# 103 SCHNEIDER ROAD STORMWATER MANAGEMENT REPORT

4<sup>TH</sup> SUBMISSION

**Re: Application for Site Plan Control – D07-12-21-0044  
103, 105 & 105A Schneider Road, City of Ottawa (March)**

Re: Site Plan Control – D07-12-21-0044 – 103, 105, 105A Schneider Road, City of Ottawa

SHEET NUMBER: SK3

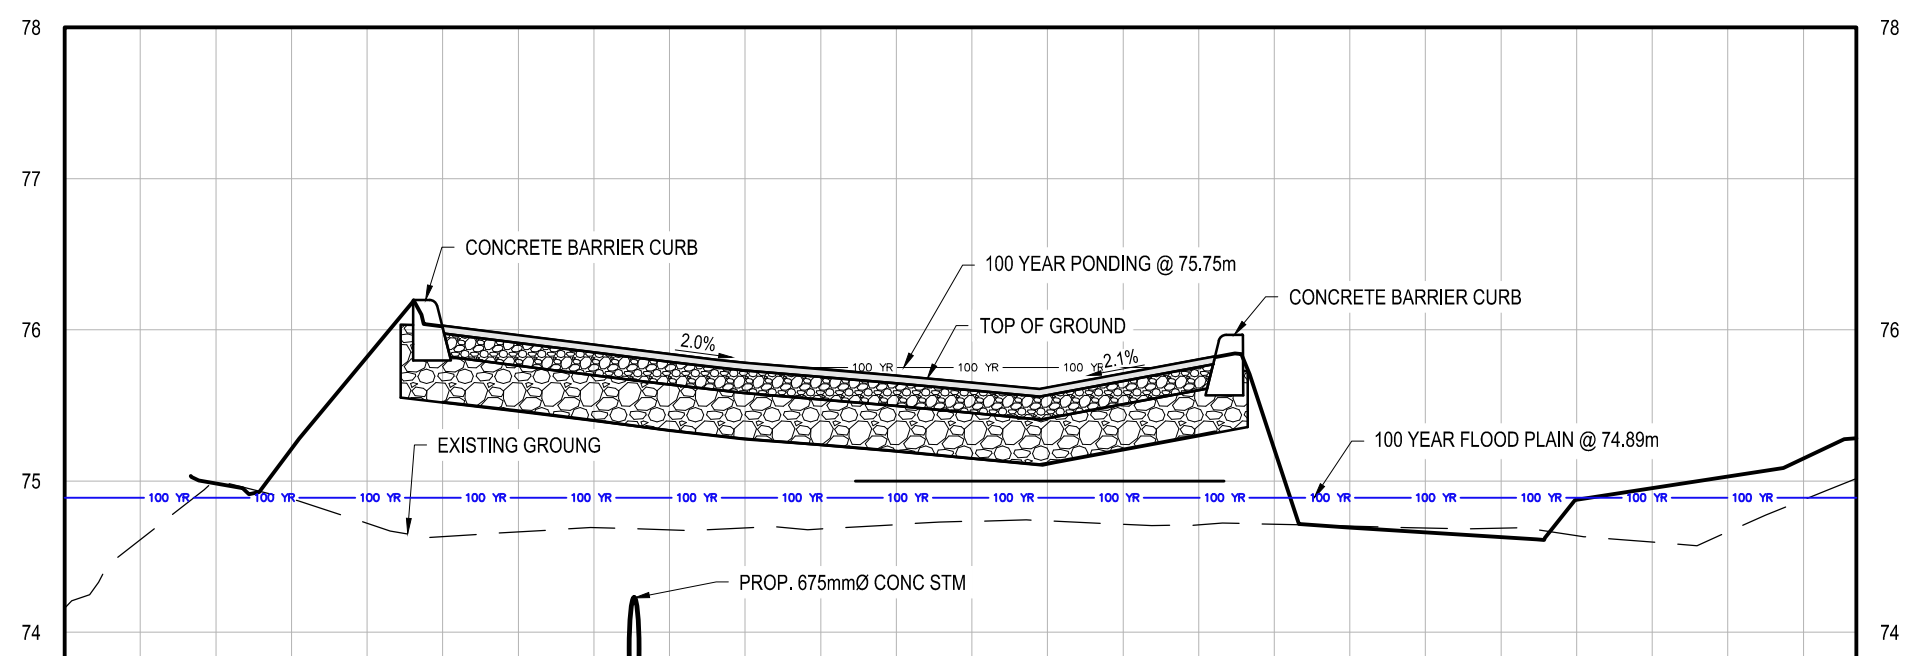
1. Drawings SK3, SK4, SK5, SK6 and SK7 have the same elevations listed for 'Finished' and 'Existing'. Please update these numbers to the actual values.
2. Please include the ponding depths for the 1:100 year storm in plan view for the existing vs. proposed flood plain.
3. The Drainage Area Plan (C05) shows flows from the adjacent property to the south moving into S-U4 Uncontrolled. Show how these flows remain outside of S-U4 or confirm that these external flows have been accounted for.
4. Section 3.2 notes that surface storage with inlet control devices will be used. Please provide the specifications, locations and ponding depths associated with the ICDs.
